Missing pieces of the 802.3dj logic baseline

IEEE P802.3dj Plenary Meeting Hawaii November 2023

Mark Gustlin – Cisco Arthur Marris - Cadence Gary Nicholl - Cisco Matt Brown - Alphawave

Figure 170–1—RS and MII relationship to the ISO/IEC Open Systems Interconnection (OSI)
reference model and IEEE 802.3 Ethernet model

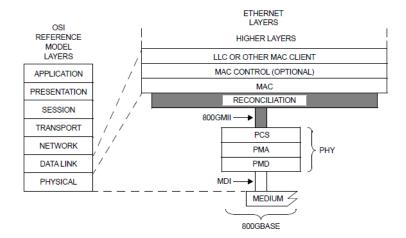
- Add 1.6Tb/s to clause 170 (MII)
 - In addition to the existing 800 Gb/s rate
- The 1.6TMII has the following characteristics:
 - a) It supports a speed of 1.6 Tb/s.
 - b) Data and delimiters are synchronous to a clock reference.
 - c) It provides independent 64-bit wide transmit and receive data paths.
 - d) It supports full duplex operation only.
- Make other changes as necessary
 - Update Figure 170-1 to add the 1.6T stack (similar to Figure 117-1)
 - · Delay constraints are on the next page

Figure 171–1—800GXS relationship to the ISO/IEC Open System Interconnection (OSI) reference model and the IEEE 802.3 Ethernet model

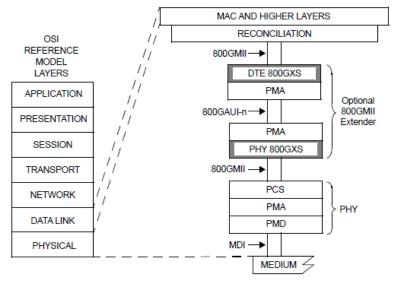
- Add 1.6Tb/s to clause 171 (XS)
 - In addition to the existing 800 Gb/s rate
 - Add the 1.6T stack into figure 171-1
- The following is a list of the major functions of the 1.6TMII Extender:
 - Simple signal mapping to the 1.6TMII
 - The optional 1.6TMII Extender can be inserted between the Reconciliation Sublayer and the PHY to transparently extend the reach of the 1.6TMII
 - Independent transmit and receive data paths
 - Each 1.6TXS leverages all functions in the 1.6TBASE-R PCS (see Clause TBD, placeholder 301)
 - Each 1.6TXS connects to a 1.6TAUI-n as shown in Figure 171–x
- Make other changes as necessary, including:
 - Diagram equivalent to figure 171-2 (functional block diagram), 171-3 (layering); but for 1.6T
 - Tables equivalent to tables 172-2, 172-3, 172-4, 172-5 status and control variable mapping; but for 1.6T
 - Service interface definitions, FEC degrade signaling etc.
